State Significant Project – Angus Place Mine Extension (SSD 12_5602)

Position of the Colong Foundation

Model of longwall mining damage to near surface groundwater aquifers (Jankowska, 2009)

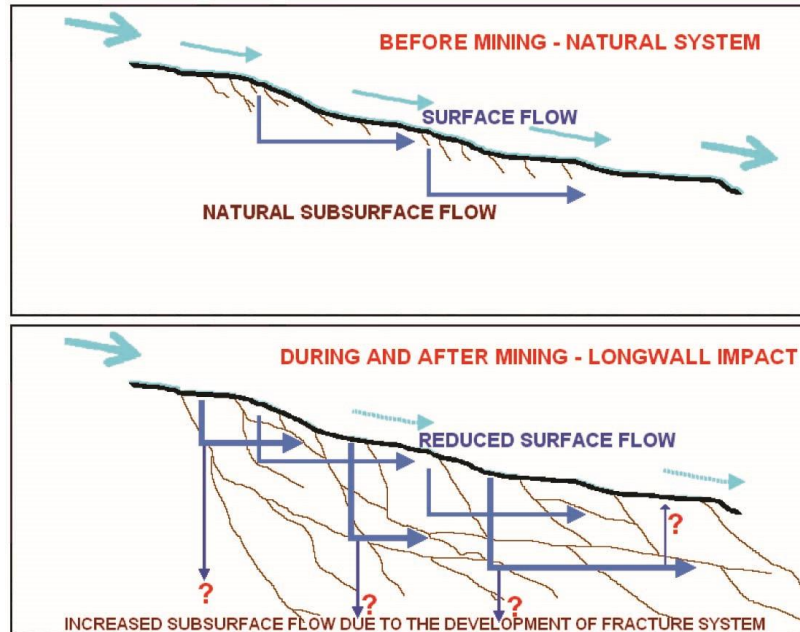
Expressed another way, the cracking across large areas of headwater catchments would increase the downwards permeability in the near-surface aquifers. This cracking of a catchment may greatly reduce the capacity of near-surface groundwater to support stream flow, such as in the case of Junction Swamp and across the headwaters of Kangaroo Creek on Newnes Plateau.

Figure 3b - Groundwater Depths - Type B Swamps

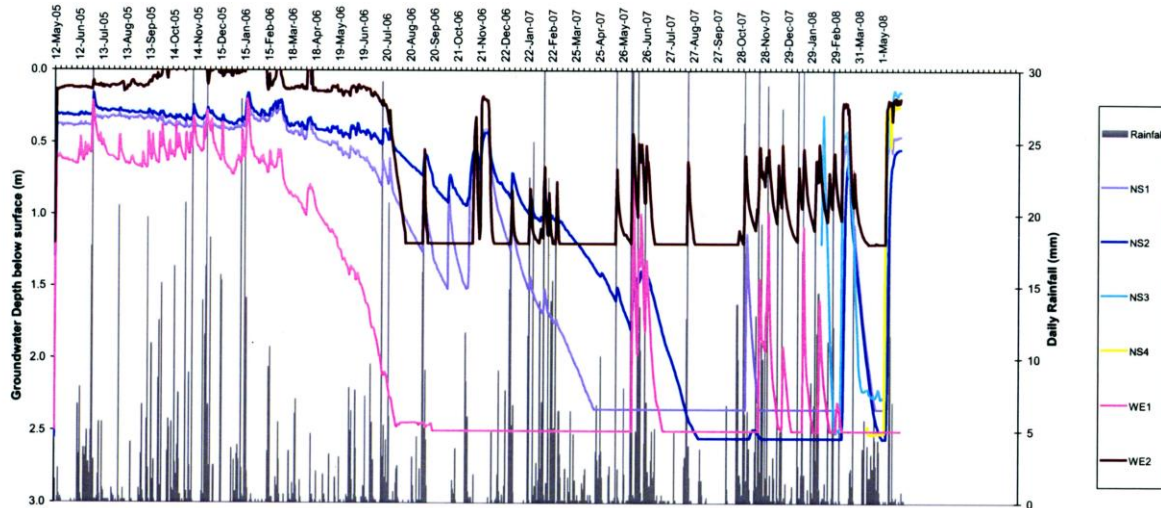
The above piezometer traces are for very shallow bore holes, all holes being less than three metres in depth. The bores for Narrow Swamp were under Angus Place longwall 950 and East Wolgan Swamp (WE 1 & 2) were located at the eastern end of longwall 960 over the coal pillars and also near Springvale longwall 411 located to the east.

Piezometer traces for Narrow Swamp and East Wolgan Swamp May 2005 – May 2008

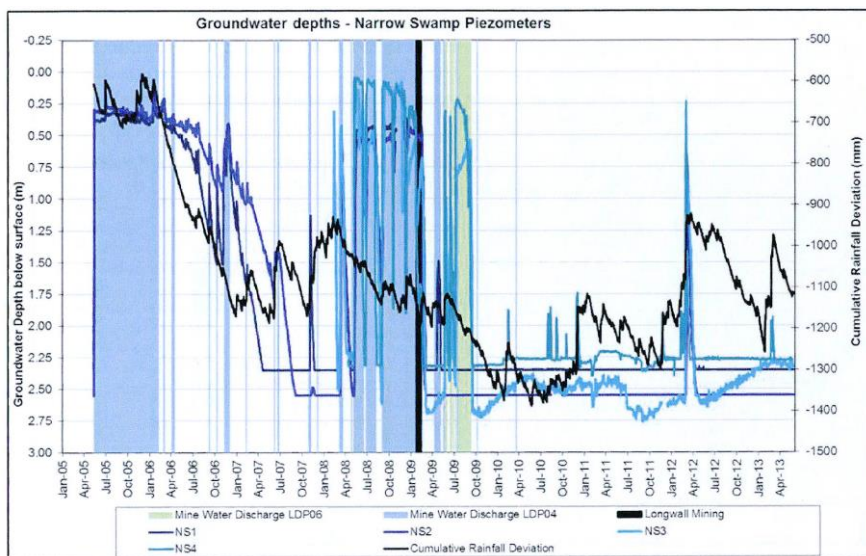
The traces in the above figure indicate the classic piezometer response to longwall mining with groundwater levels falling to the bottom of the hole and staying there, except during heaving rain events. Centennial Coal claims its mining will not impact on swamps but has little evidence to support its claim.
